MEMORANDUM

TO: Development Review Board
FROM: Ryan Morrison, Associate Planner
DATE: September 6, 2022
RE: 22-307; 120 Depot Street

Request: Construct a single-family residence on a vacant property, and after the fact tree removal.

(h) Building location and orientation

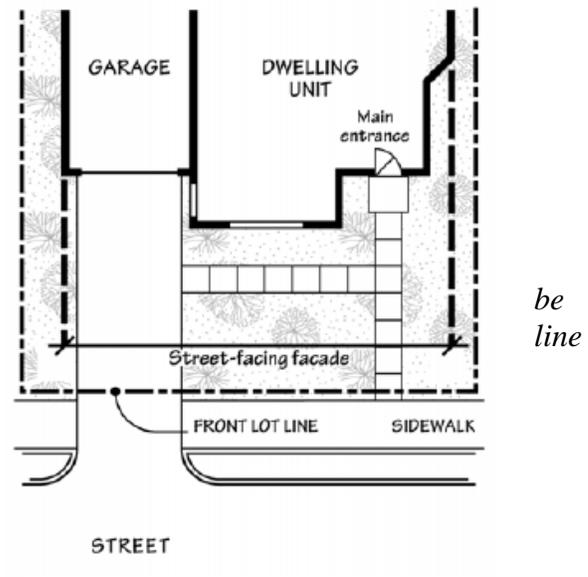
This proposal will be the first development fronting Depot Street, so there is no existing development pattern to maintain here.

This is a unique design where the garage is the only portion at the street level. As proposed, a clearly identifiable entrance is included.

The property received variance approval (ZP-21-508) for a 10 ft front yard setback, and thus the minimum 25’ garage setback does not apply here. The garage will provide ample room for two vehicles. The plans show the garage to be setback 6 inches from the longest street facing wall of the principal structure – the mid-level living space above. **Affirmative finding.**

Where a garage is attached to a principal single-family or duplex residential structure and oriented to the street (i.e. the garage doors face the street) the following standards shall apply:

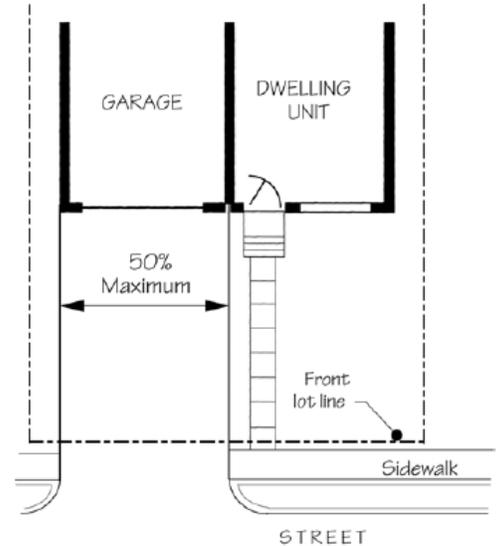
The street-facing wall of the garage constitutes more than 50% of the width of the street-facing façade and living space is required above. But what constitutes ‘above’ here? The upper living space is only connected to the garage via an elevator/stair shaft, with an approximate 22 ft open-air gap between the two. Due to the large gap between the garage and upper living space, compliance with this requirement is questionable. The DRB is requested to make a determination on whether or not the proposed layout meets the intent of this provision. **No finding possible.**

The garage doors are proposed at 10 ft in width. **Affirmative finding.**

The garage exceeds 50% of the total façade width and is not within a single roofline and wholly integrated into the design of the front façade. **Adverse finding.**
